DOCUMENT 00 90 00
ADDENDUM

ADDENDUM: 2

PROJECT: WESTERN TECHNICAL COLLEGE
SPARTA PUBLIC SAFETY TRAINING SIM CITY
11177 COUNTY HWY 1
SPARTA, WISCONSIN 54656
PROJECT NO. 25039

FROM: HSR Associates, Inc
100 Milwaukee Street
La Crosse, WI 54603
(608) 784-1830

3 RESIDENTIAL UNIT " B " LIGHTING PLAN
1/4" = 1'-0"

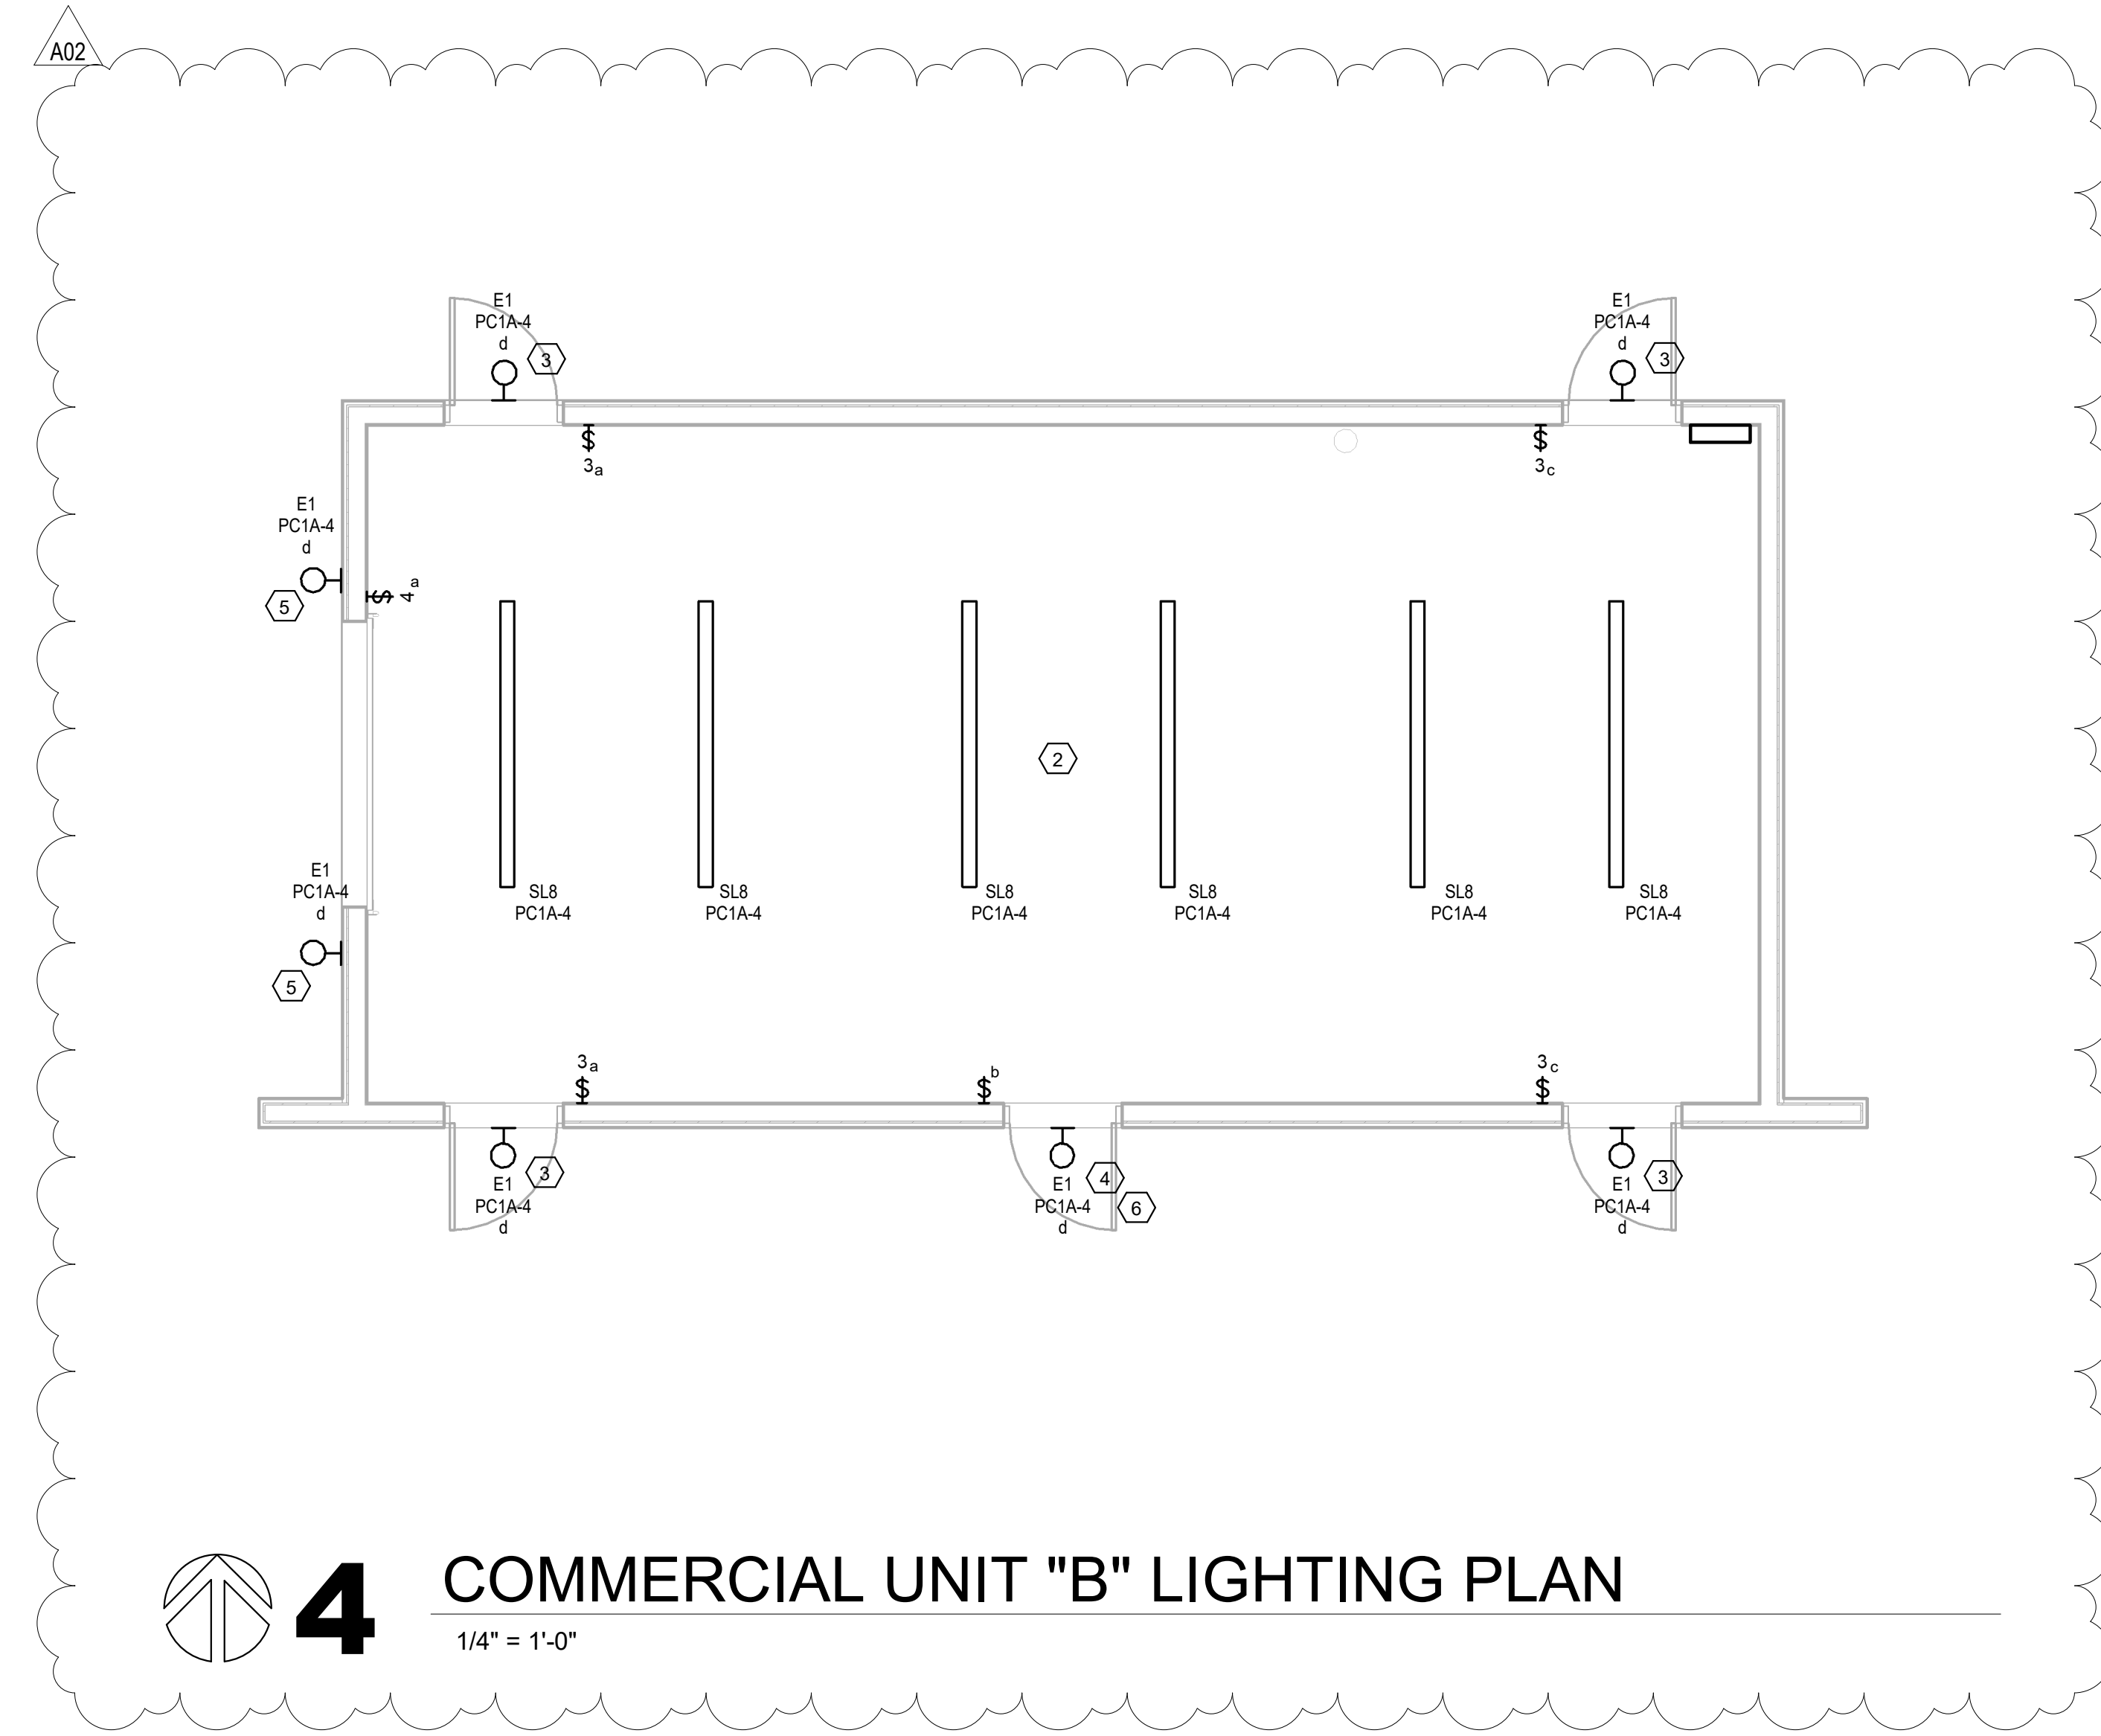
- a. See the revised sheet included in this addendum. Disregard the previous version.
- b. Added detail 4/E100 regarding Commercial Building B.

1 RISER DIAGRAM
NTS

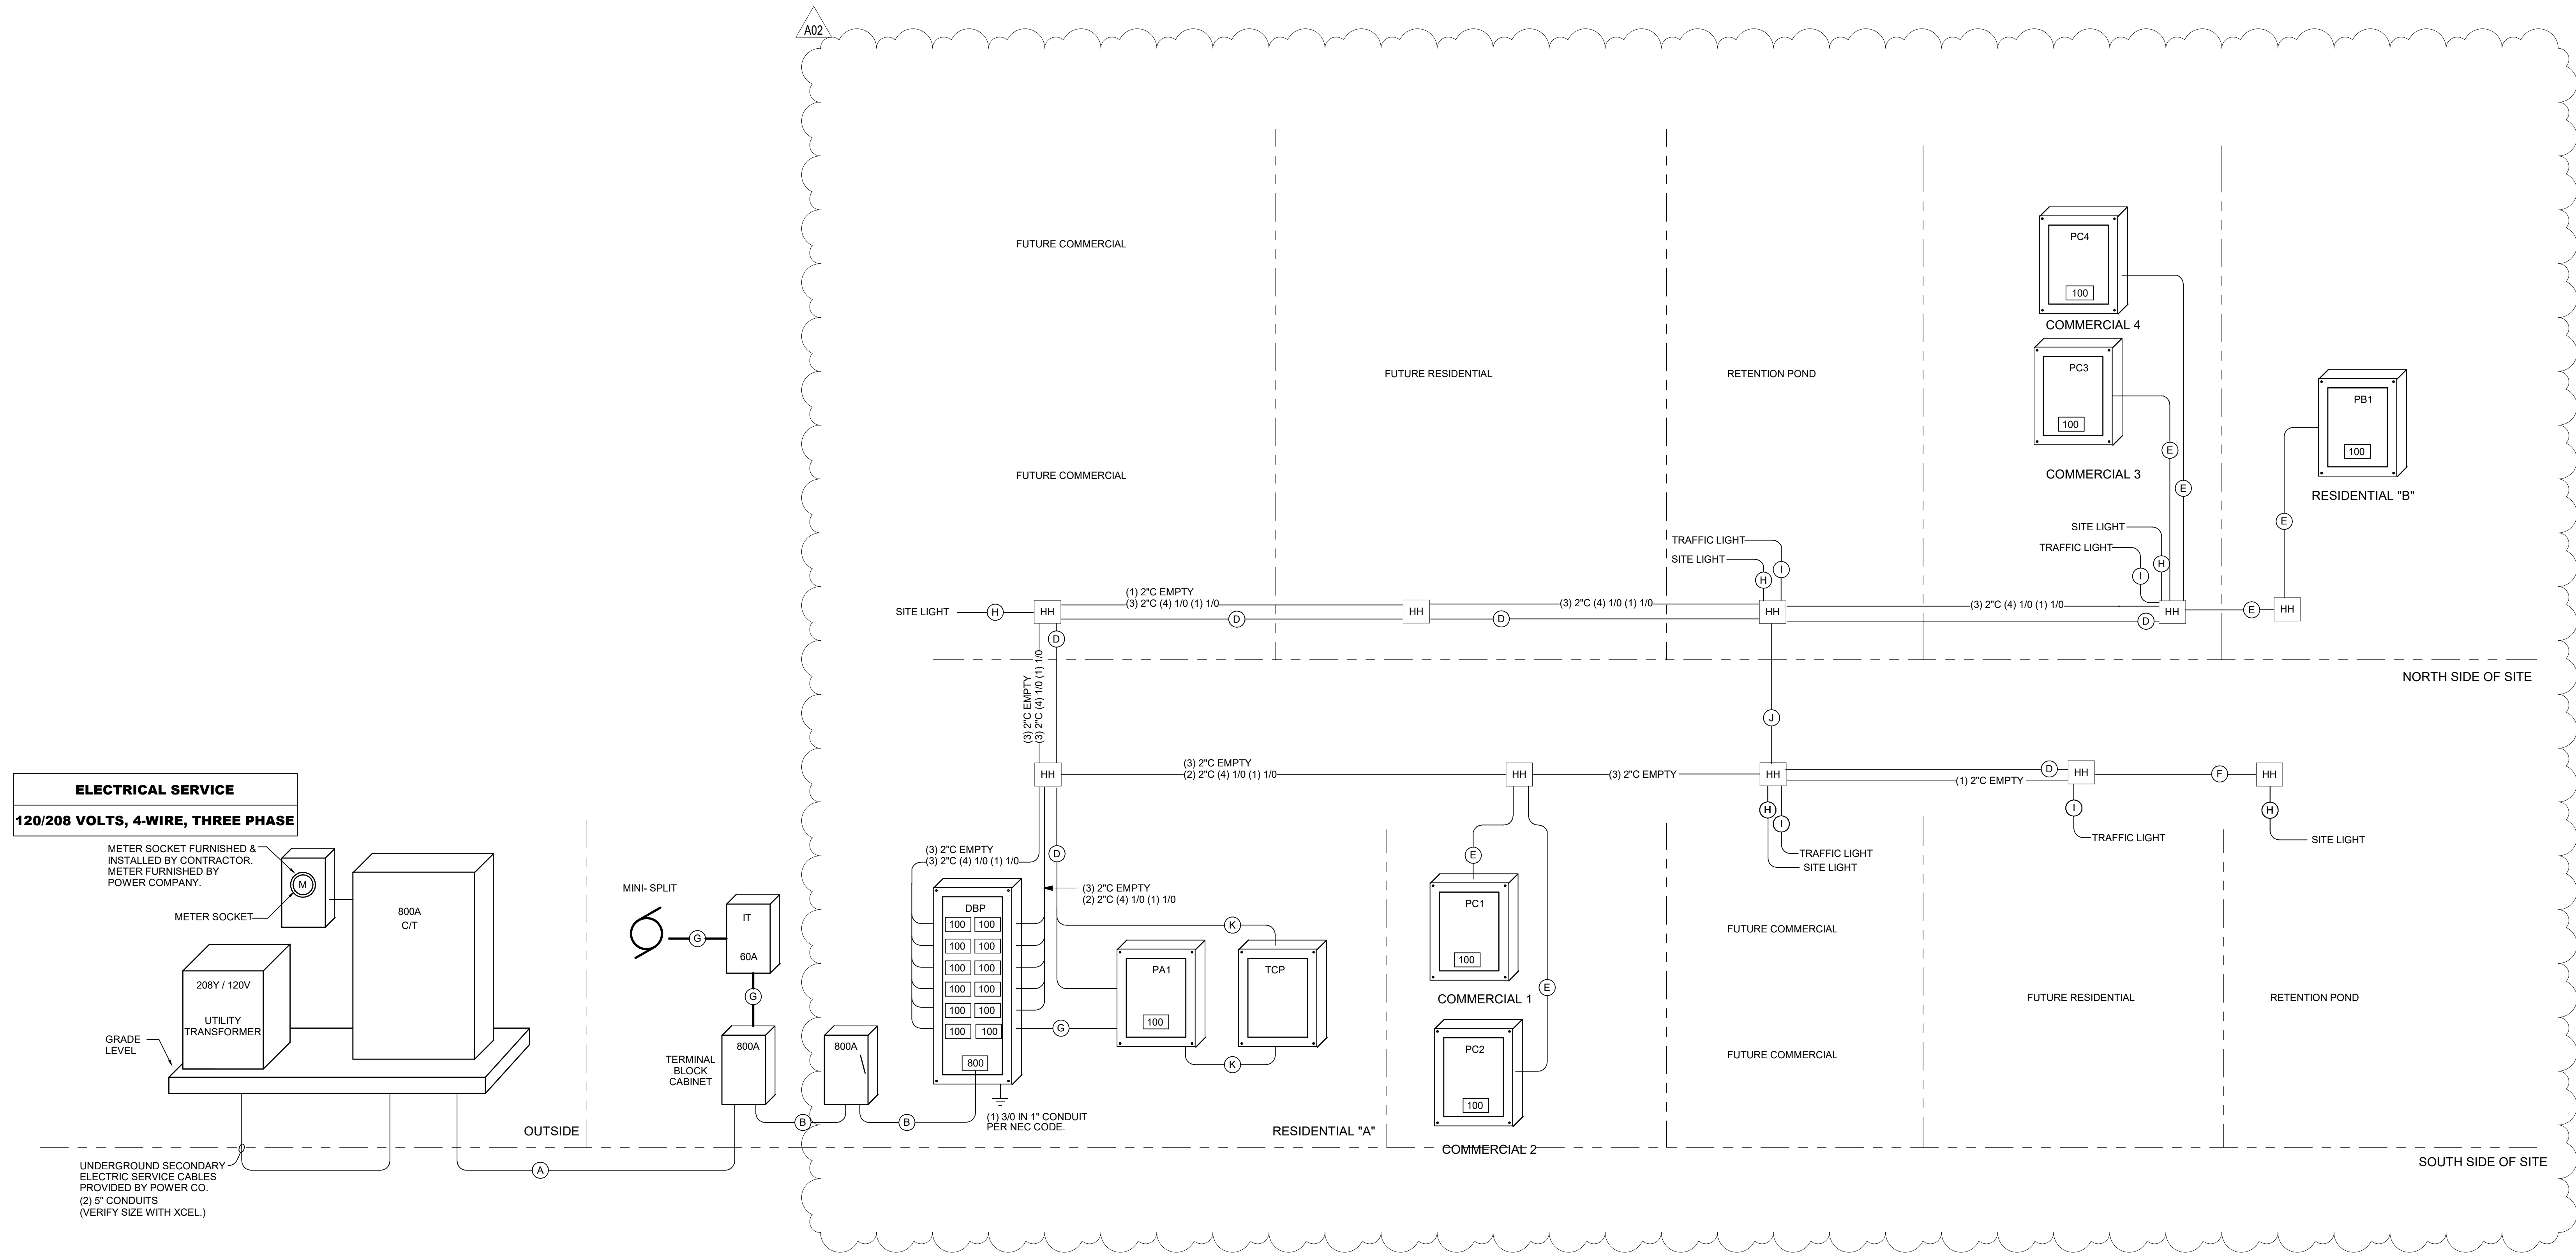
- a. See the revised sheet included in this addendum. Disregard the previous version.
- b. Revised Feeder Schedule and Riser Diagram.
